Service Bulletin

PRELIMINARY INFORMATION

Brand:	Model:	Model Year:		VIN:		Engine:	Transmission:
		from	to	from	to		
Cadillac	Escalade Models	2015	2016	ALL		ALL	ALL
Chevrolet	Suburban, Tahoe Models	2015	2016	ALL		ALL	ALL
GMC	Yukon Models	2015	2016	ALL		ALL	ALL

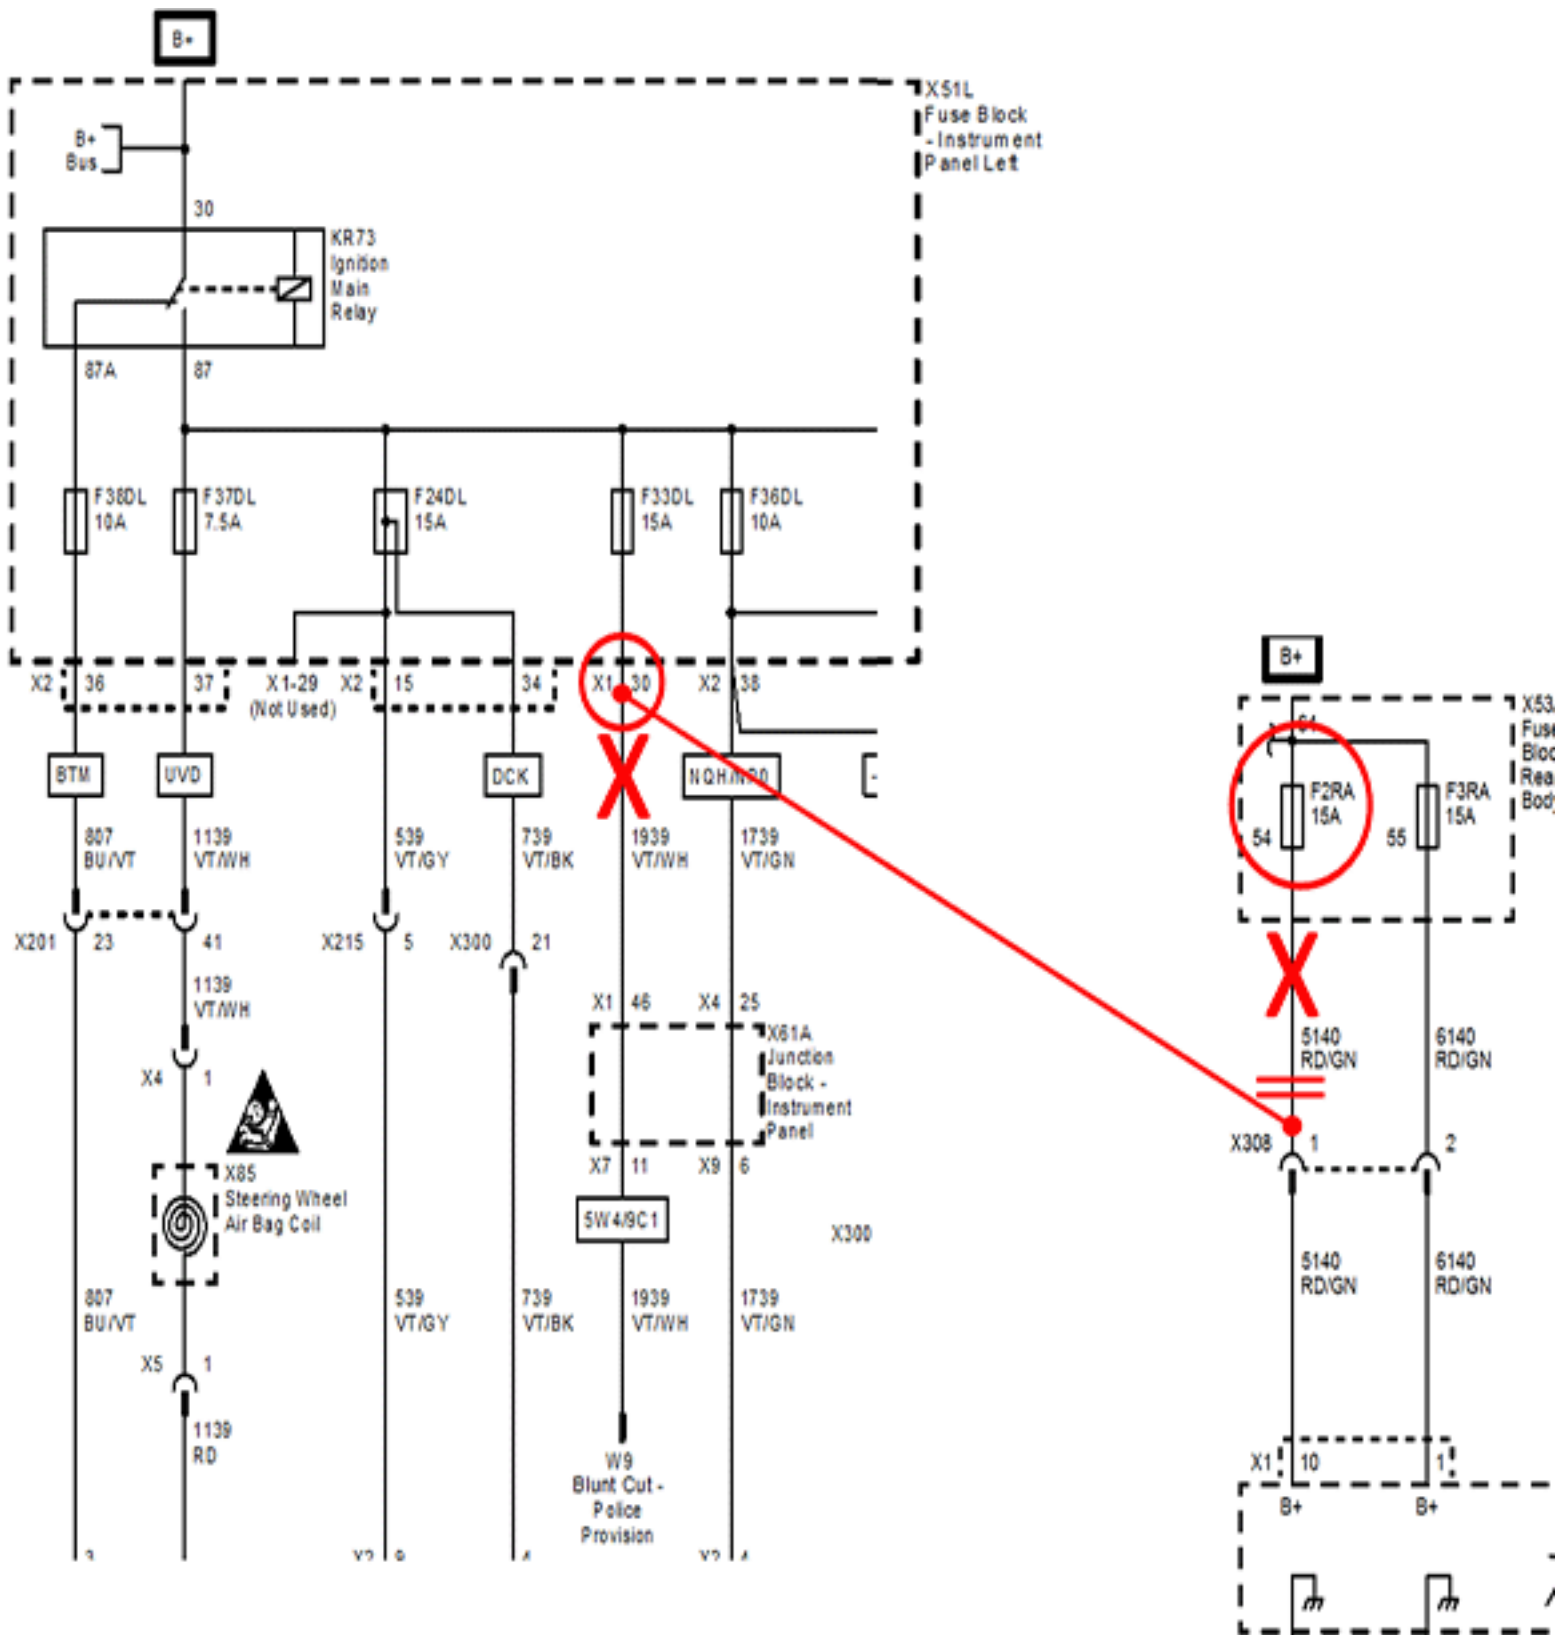
To correct this concern, rework the Rear Heated Seat Control Module power circuit 5140 from a hot-at-all-times fuse to a hot-in-run/crank fuse by following the instructions listed below.

Use the wiring diagram shown below to help understand the rework. When printing the wiring diagram, do not adjust the size in the browser window. First, select the magnifying glass to enlarge the schematic and then print a copy of it.

1. DISCONNECT THE BATTERY
2. At the Left I/P fuse panel (X51L), back out circuit 1939 at X1-30 and tape it back into the wiring harness, as it will no longer be used.
3. Obtain a length of 18 ga wire long enough to run from the Left I/P fuse panel (X51L) down along/under both left side sill plates to reach X308, which is located under the left side of the 2nd row seat. Connect a terminated lead, part number 19301767, using a salmon colored crimp-and-seal, part number 19300089, to one end of the wire. Install this into X1-30 of the Left I/P fuse block (X51L).
4. Route the wire, as shown below, from the Left I/P fuse panel (X51L) (1) down along/under both left side sill plates to connector X308 (2). Use tape and conduit to secure and protect the wire from damage. Where possible, install the new wire in the existing wiring trays under the sill plates.

5. Cut circuit 5140 a few inches from X308, as shown in the wiring diagram, and tape off the fuse block side as it will no longer be used.
 6. Attach the other end (seat side) of circuit 5140 to the new 18 ga wire, which was run from the Left I/P fuse block (X51L) with a salmon colored crimp-and-seal part number 19300089.
